A G E N D A

Architectural Review Board

September 24, 2019

UNION STATION
PROPOSED SCULPTURE LOCATION

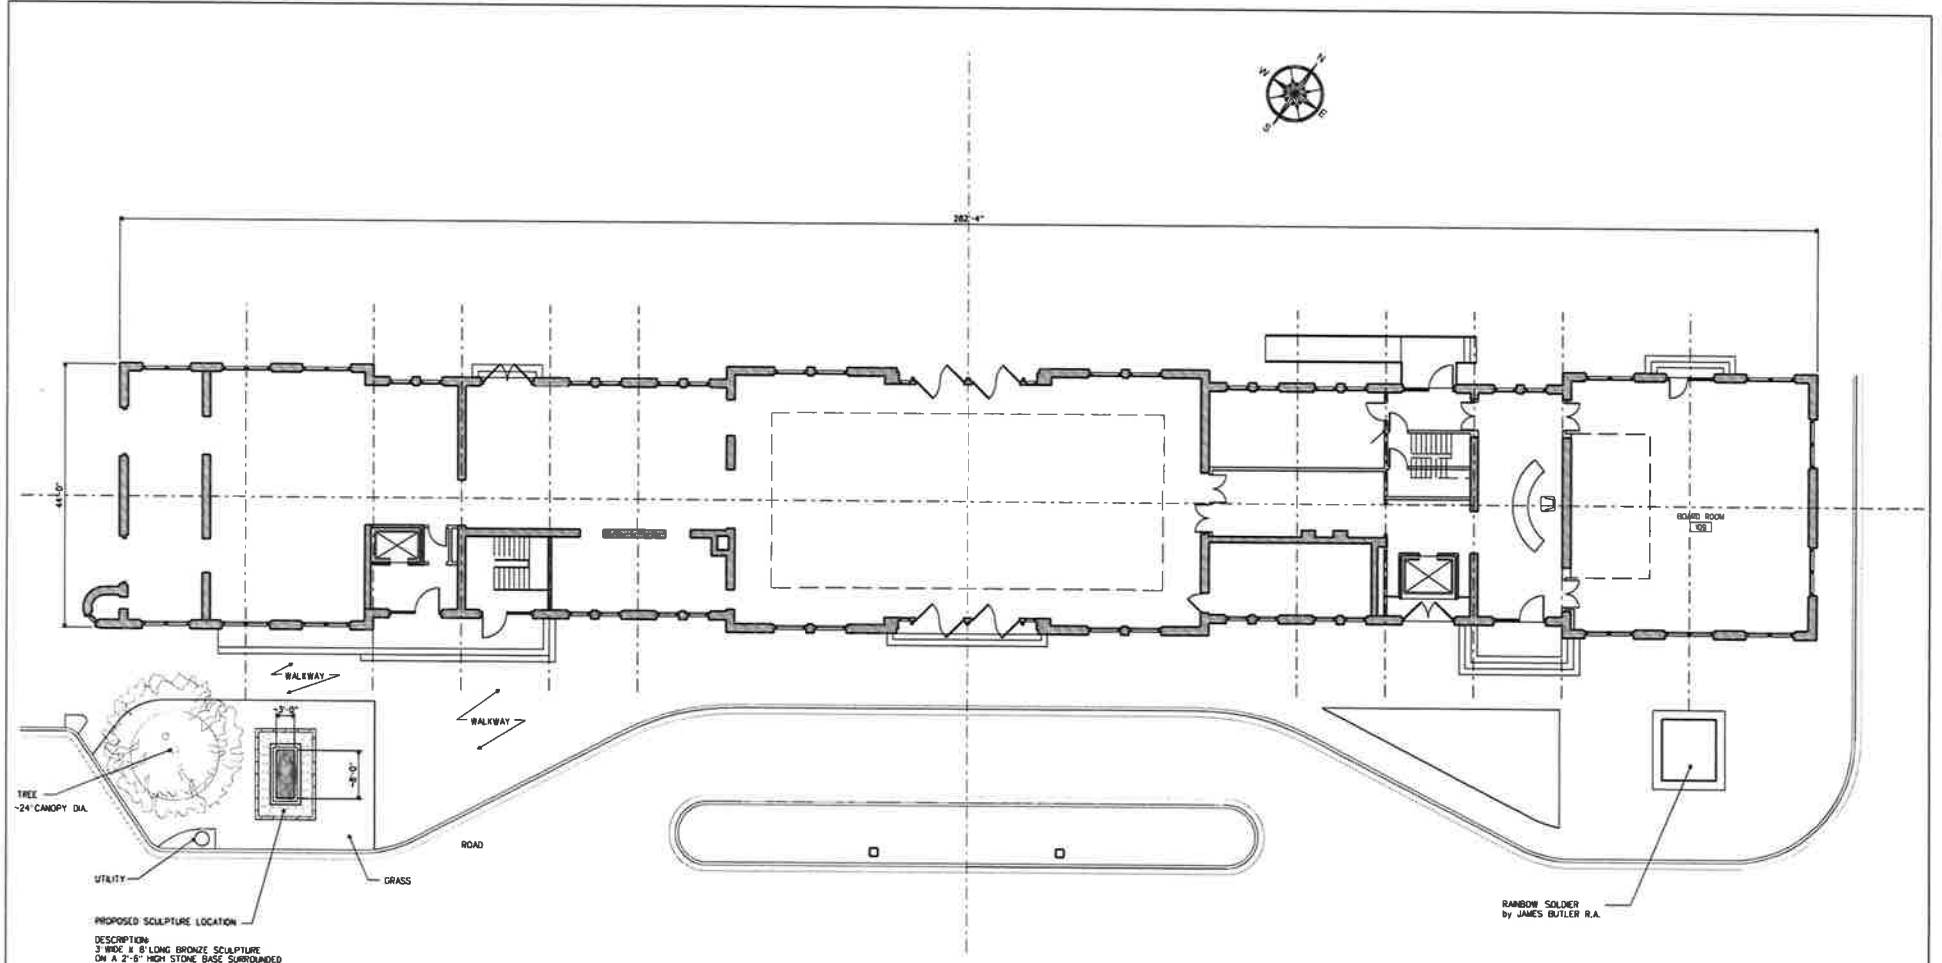
At the July 23, 2019 ARB meeting, the ARB requested a more detailed rendering of the statue in situ and a site/landscape plan detailing the new landscaping and hardscaping associated with the installation. Renderings are attached.

- When evaluating public art, the Board is reminded they are not evaluating the content of the subject matter, but evaluating whether the proposed size and placement of the installation is visually disruptive to the adjacent historic resource or physically impacts historic materials.
- As rendered, the visual impact on Union Station is minimal.

EAGLE RIB

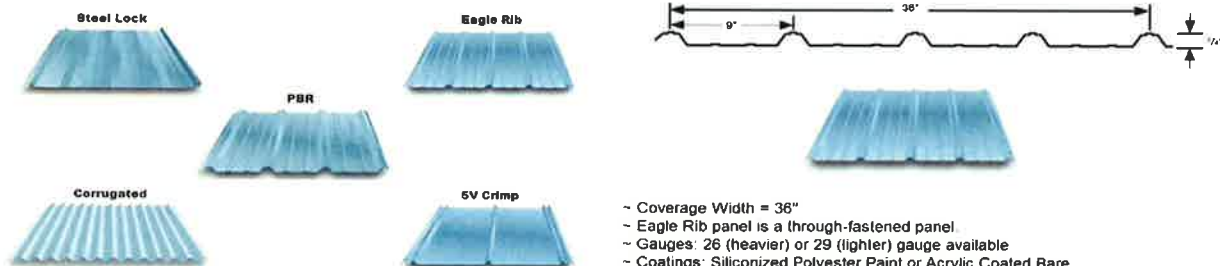
- The Board has approved the use of metal on porch roofs since the slopes are often such that only a rolled roofing is the only other viable option.
- When petitioners have requested metal prior to installation, the Board has generally asked for a more historic crimp (5-v crimp) unless there is another metal present to match.
- The Board is reminded that they are to review the violation as though permission was being requested first, and that just because the alteration has been made, the Board does not have to approve it. If a change is required or the petition is denied, a timeframe for compliance should be set as part of the motion.

1801 St. Charles Avenue

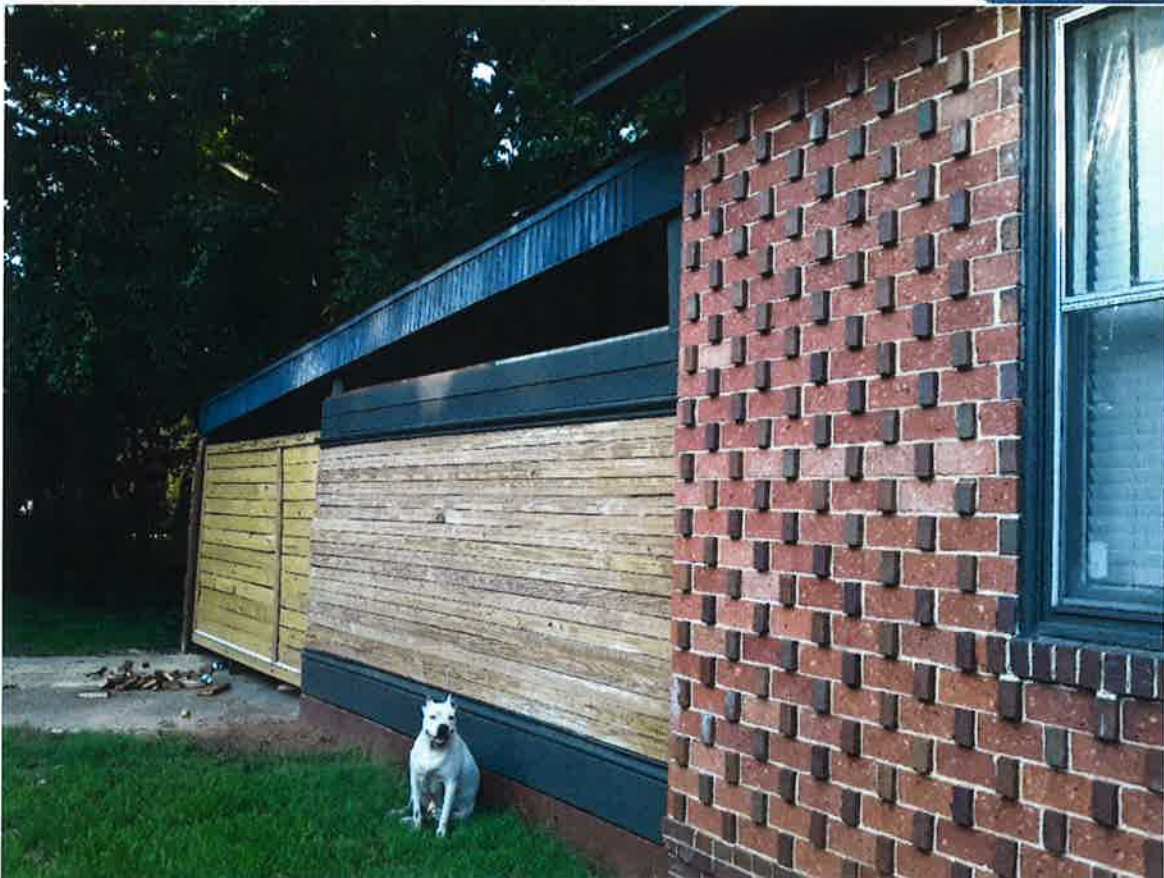
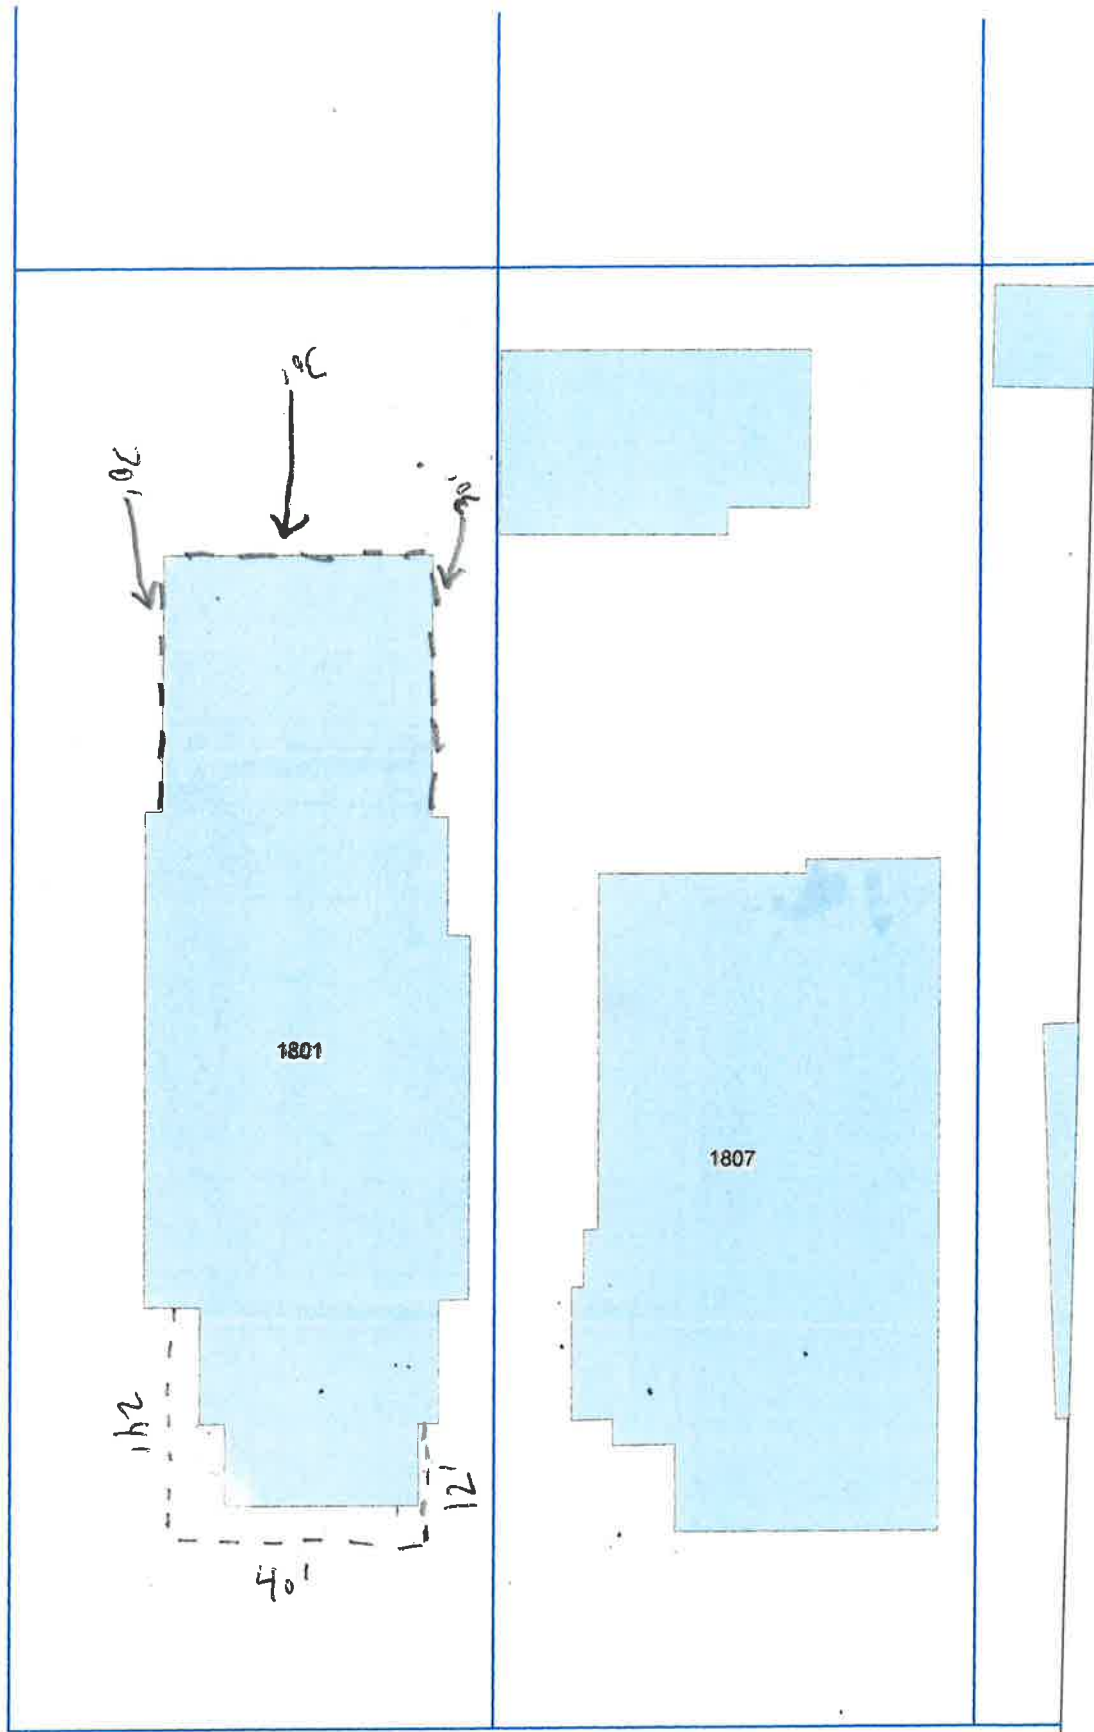
- Initial discussions with the petitioner included the installation of landscaping around the fence to create more of a focal point with the fence as a garden feature versus a full front yard enclosure. That was not part of the submission.
- The Board is reminded that they are to review the violation as though permission was being requested first, and that just because the alteration has been made, the Board does not have to approve it. If a change is required or the petition is denied, a timeframe for compliance should be set as part of the motion.

NORTH ELEVATION

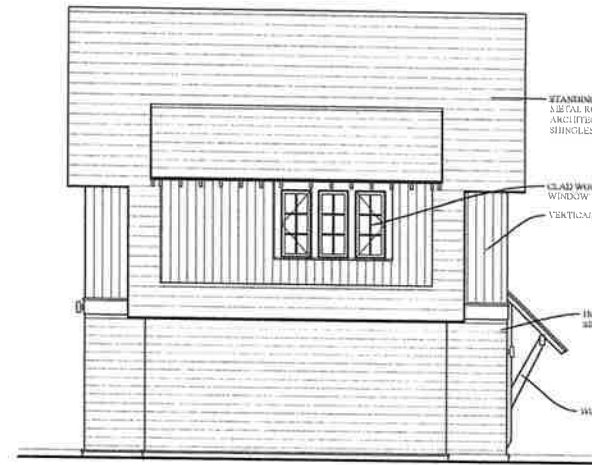
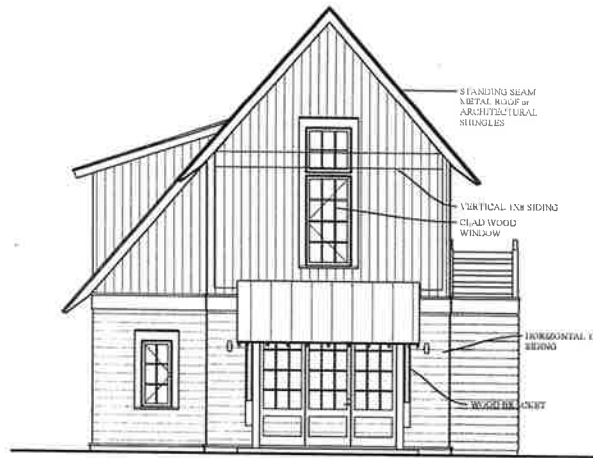
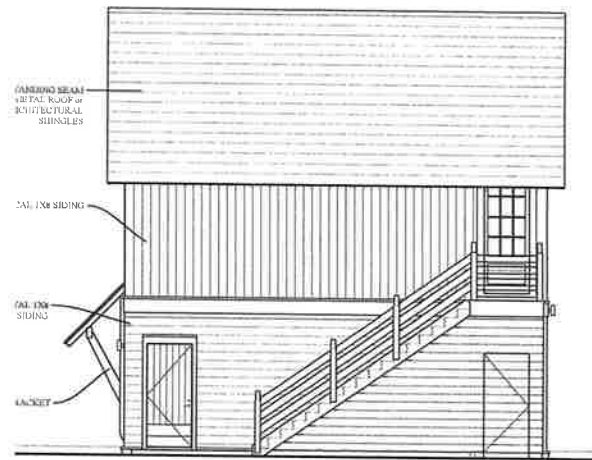
- Proposal meets Smart Code requirements, materials and design match the previously approved house plan.
